UZBEKISTAN GAS TO LIQUID PROJECT (UZGTL)

HAZOP ACTION CLOSE-OUT REGISTER FOR MAKE-UP H2 COMPRESSOR PACKAGE

UZGTL-HDC-HSE-RP-50-0-0004

OLTIN YO'L GTL	HAZOP ACTION CLOSE-OUT REGISTER FOR ERG COMPRESSOR PACKAGE	 HYUNDAI <small>ENGINEERING CO., LTD.</small>  ENTER <small>ENGINEERING</small>
--	---	--

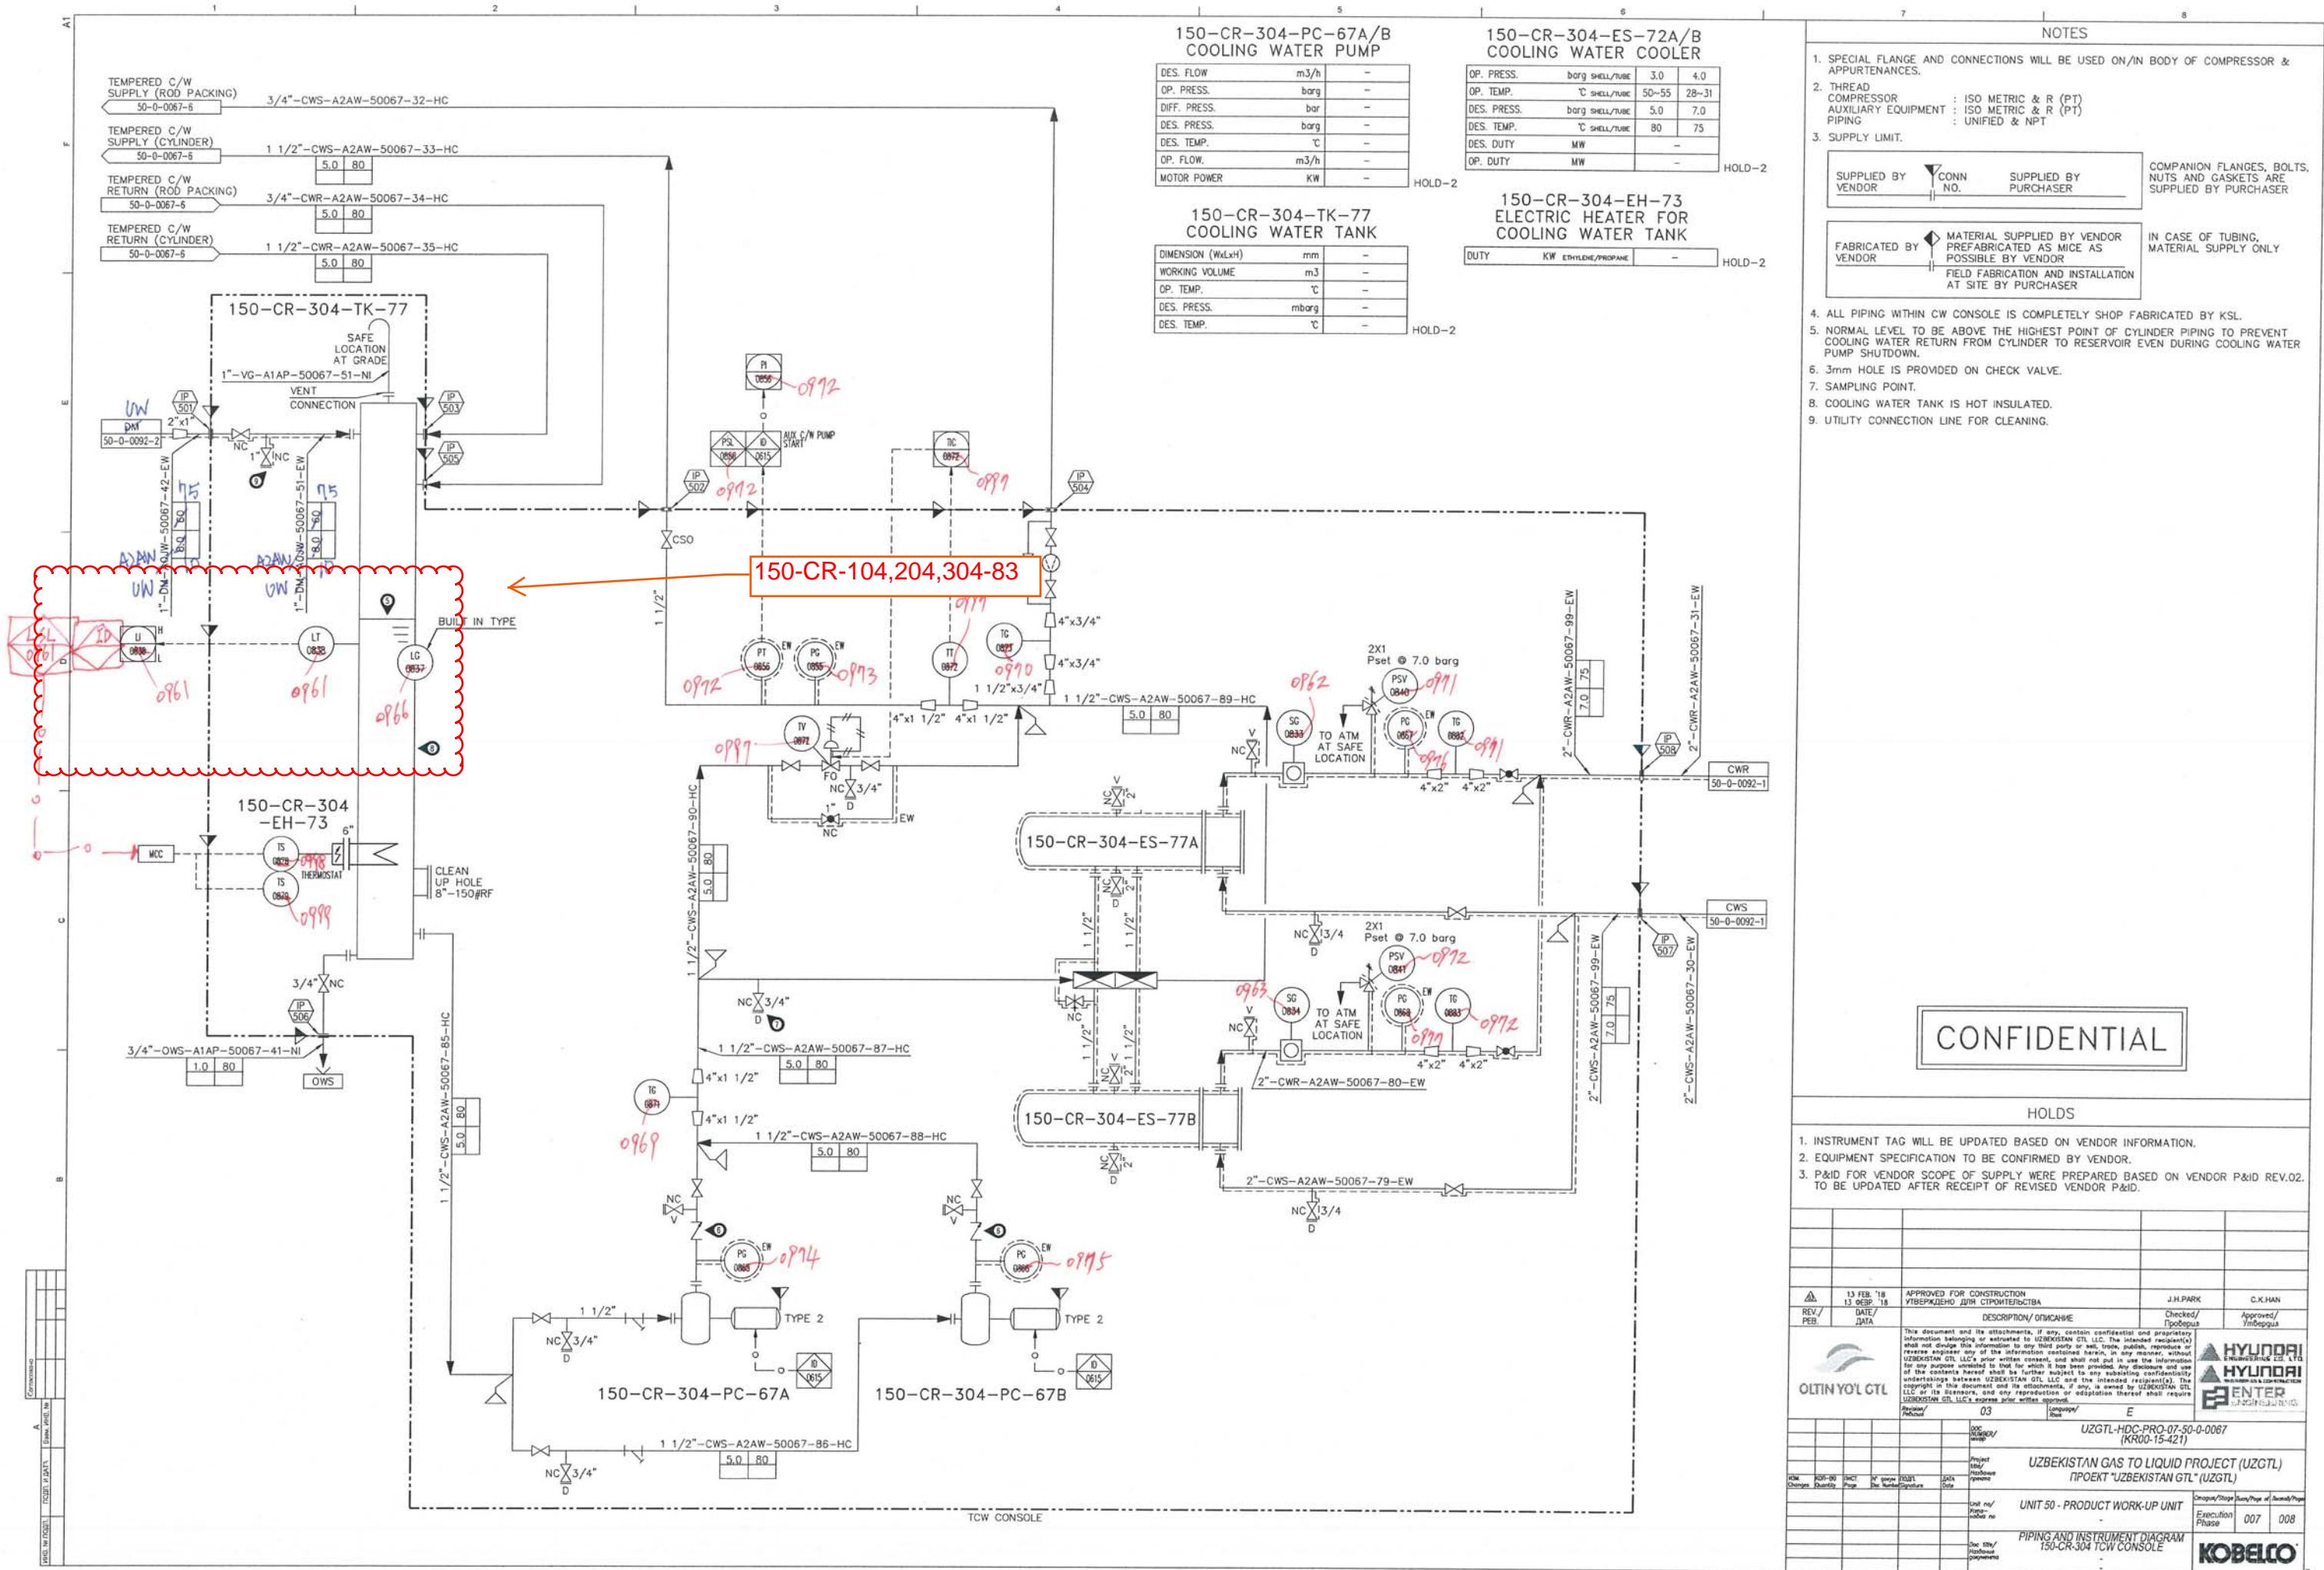
Action No.	150-CR-104/204/304-83				
Action By	PR				
Node No.	3				
Node Description	3. Cooling Water / TCW console				
Cause	3.5.1. Cooling Water Cooler tube rupture 3.10.1. Cooling Water Tank overfilling due to incorrect refilling				
Consequence	3.5.1.1. Cooling water flow from tube side to shell side leading to overfilling of Cooling Water Tank. Potential fouling of cooling jackets. 3.10.1.1. Loss of cooling water. No significant issue.				
Safeguards	3.5.1.1.1. Vent routed at grade level acting as overflow line (Refer to Recommendation) 3.10.1.1.1. Vent routed at grade level acting as overflow line (Refer to Recommendation)				
Action	Configure 150-LAH-0838A on DCS

Response	Incorporated on P&ID (50-0-0065/66/67-7). 150-LAH-0838A on DCS is provided on AFC P&ID. (Please refer to attached P&ID, UZGTL-HDC-PRO-07-50-0-0065/66/67-7)				
CONTRACTOR			OWNER		
Position	Signature	Date	Position	Signature	Date
Process Engineer	<u>B.M.Hwang</u> 	10-Apr-2018		_____
